**Enclosure 3 to E-54658**

**RAI Responses with associated application  
change pages**

**License Application, Attachment A, "Proposed License Conditions"**

**Figure K.3.1-1**  
**61BT-DSC Confinement Boundary**

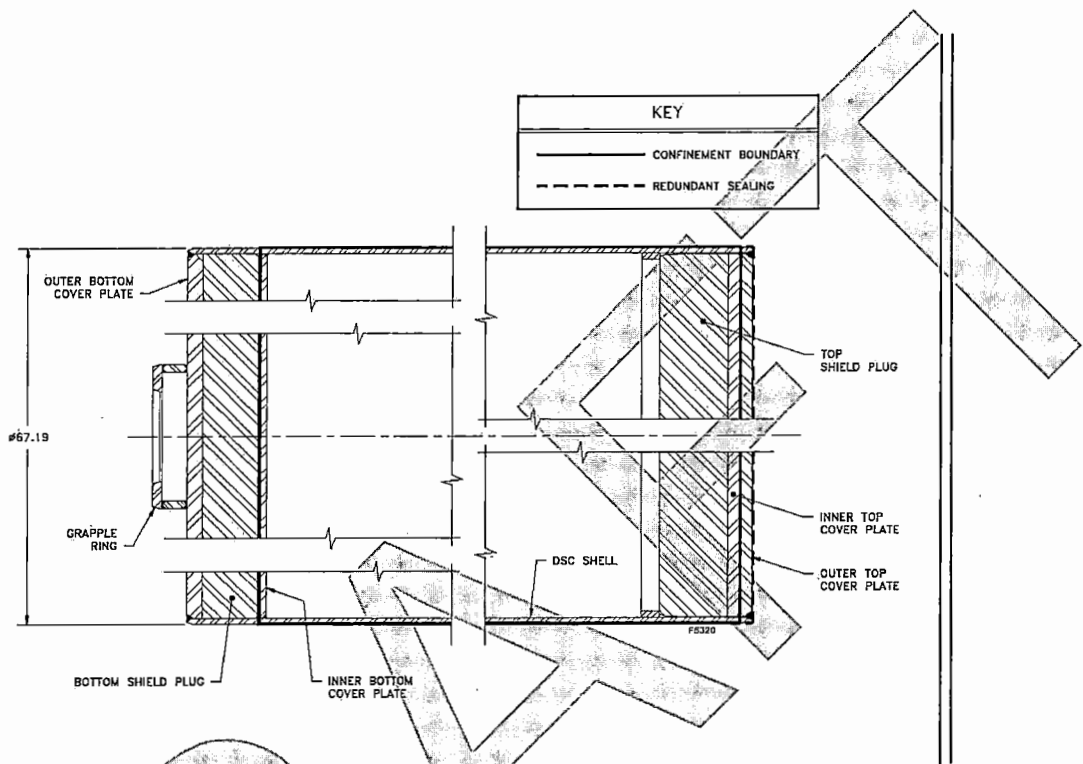
Clarify the terms, "to the extent practicable," and, "by this test," contained in Proposed License Condition 22 which states, "Prior to removing the shipping cask closure lid, the gas inside the shipping cask shall be sampled to verify that the canister confinement boundary is intact *to the extent reasonably practicable by this test.*"

As written, the license condition is vague and does not identify a specific procedure, test, or acceptance criteria.

ISP has revised the License condition to clarify that the test to be performed is that referenced in Sections 5.1.3.1, 7.2, 8.2 and the operating procedures in the appendices in accordance with QP-10.02. License Condition 22 is revised to read, "A Post-Transportation Verification shall include an evacuated volume helium leak test on 100% of the canisters that are received at the WCS CISF to ensure that the accessible portions of the confinement boundary are leak tight as defined in ANSI N 14-5 following transport to the site." The language in Section 4.5.5 of the SAR is also updated consistent with this change.

The confinement boundary of each canister is leak tested in accordance with ANSI-N 14.5 during fabrication and during closure of the canister. The reference "to the extent practicable" is meant to acknowledge the fact that due to the geometry of the canisters it is impossible to leak test the entire confinement boundary once fabrication and closure of the canister is complete. Incorporation by reference is employed in Sections A.11.1, B.11.1, C.11.1, D.11.1, E.11.1.1, E.11.2.1, F.11.1.1 and G.11.1.1 to define the confinement boundary for each canister. By way of example, SAR Section C.11.1 incorporates Figure K.3.1-1 by reference from TN Document NUH-003, Revision 14, "Updated Final Safety Analysis Report for the Standardized NUHOMS® Horizontal Modular Storage System for Irradiated Nuclear Fuel." (Basis for NRC CoC 72-1004). Figure K.3.1-1 from the NUHOMS® SAR provides the figure that shows the components and welds that make up the confinement boundary for the 61BT DSC. Figure K.3.1-1, reproduced below, shows that portions of the confinement boundary are enclosed by other welded components (bottom cover plate, top cover plate etc.). Since all of the other canisters have similar designs, Figure K.3.1-1 is representative for all.

**Figure C.7-21**  
**Top End Drop Buckling**

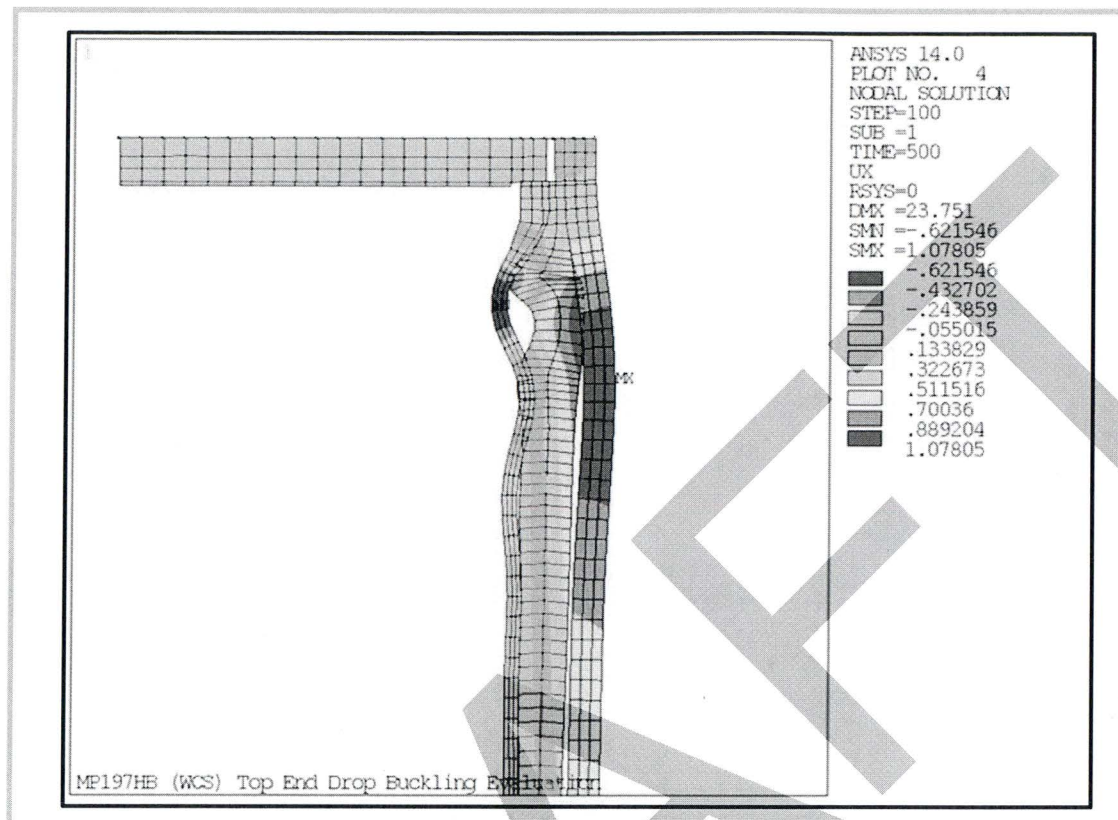
In WCS CISF SAR Figure C.7-21, "Top End Drop Buckling," revise the erroneous abscissa labeling, "Time," to read, "Deceleration (g)," as appropriate to recognize that the canister end drop buckling capability is tracked against the load, in lieu of time increment.

As described in Section C.7.7.3.5 of WCS CISF SAR, Figure C.7-21 represents the buckling deformation at the buckling location for the top end drop. The plot at the bottom of Figure C.7-21 was for information only, based on the ANSYS contour plot at the top of this Figure. The plot has been taken out to avoid confusion, and the words "and radial displacement curve" under Section C.7.7.3.5 on Page C.7-26 have been removed.

SAR Figure C.7-21 and Section C.7.7.3.5 have been revised as described in the response.
